REPORT OF THE INDEPENDENT HEARING & ASSESSMENT PANEL

Pursuant to s75G of
Environmental Planning and Assessment Act 1979

Proposed Intermodal Logistics Centre, Enfield

October 2006

Figure 6.1: Noise assessment and monitoring locations used in the EA

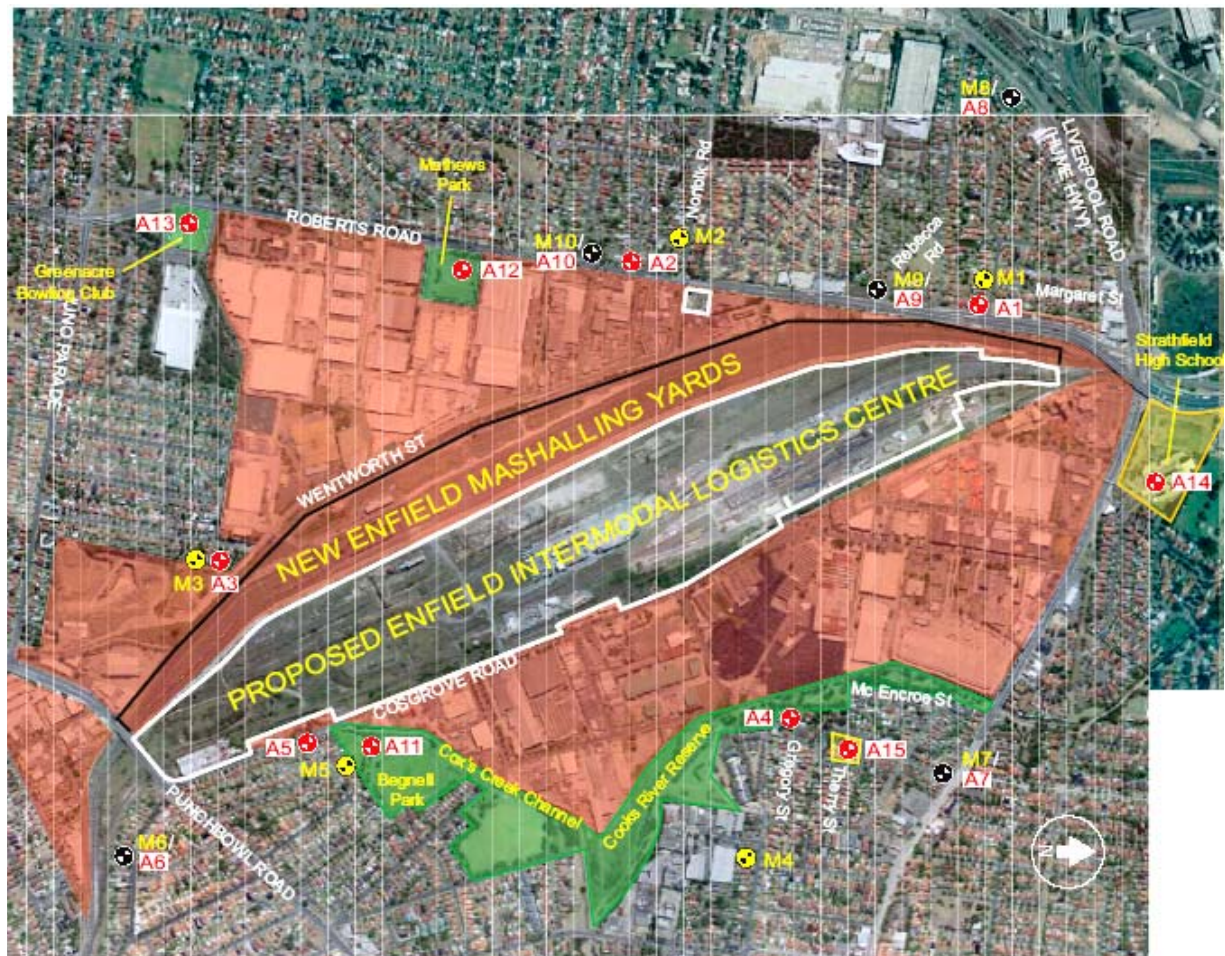
The Panel considers that the noise assessment locations and the noise monitoring locations are adequate for a project this scale because all potentially affected residential areas and noise sensitive land uses were covered.
